PG&E Letter DIL-03-002

Docket No. 72-26
Diablo Canyon Independent Spent Fuel Storage Installation
Revised and Supplemental Responses to NRC Request for Additional Information
for the Diablo Canyon Independent Spent Fuel Storage Installation Application
(TAC No. L23399)

# Supplemental Information to Request for Additional Information for Diablo Canyon Independent Spent Fuel Storage Installation (ISFSI) License Application

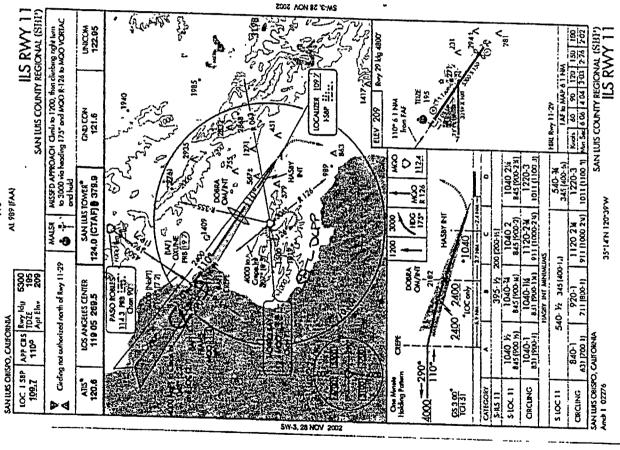
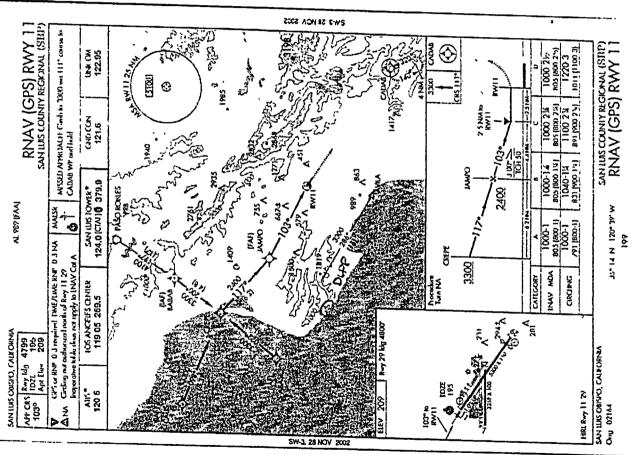
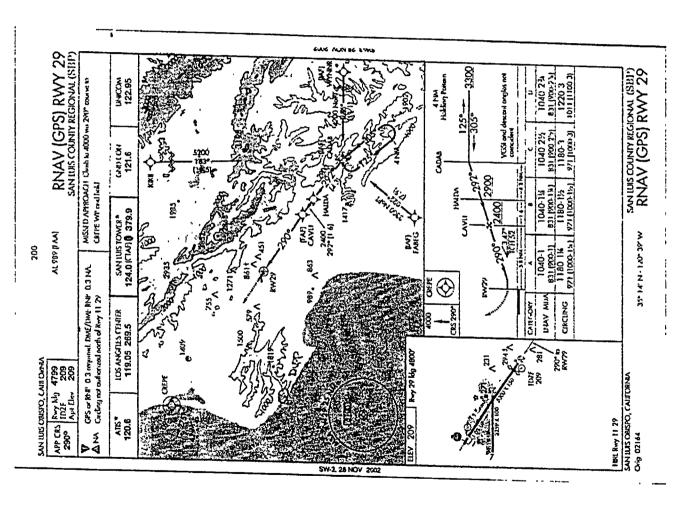
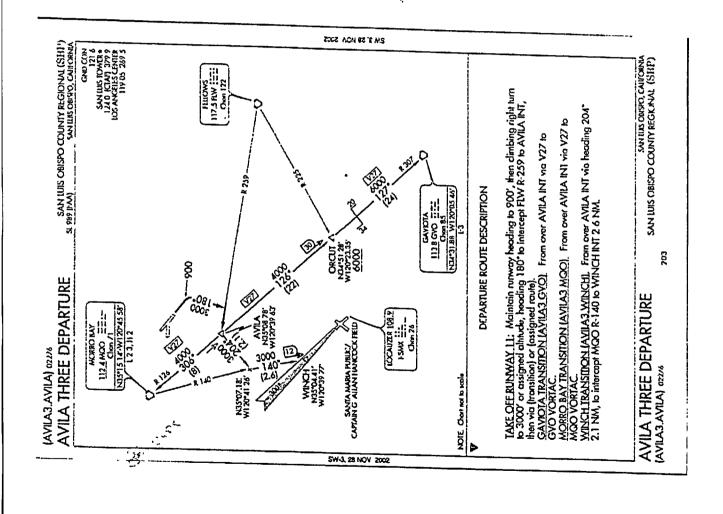
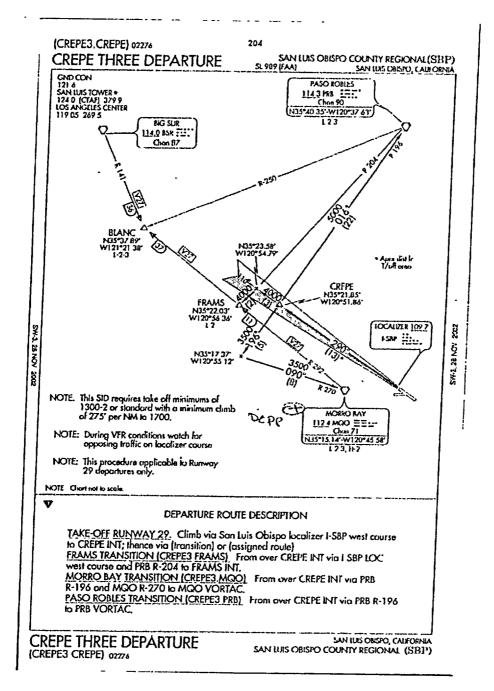
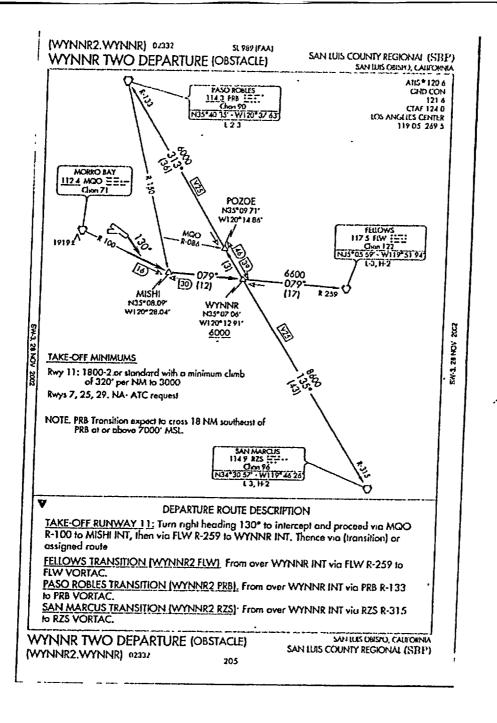
Need plot for holding patterns for arrivals and missed approach (e.g., CREPE and CADAB intersections and Morro Bay VOR) relative to the proposed site.

The terminal procedures are included as Attachment 1 to this submittal. DCPP is not shown on approach charts, but its location has been marked.
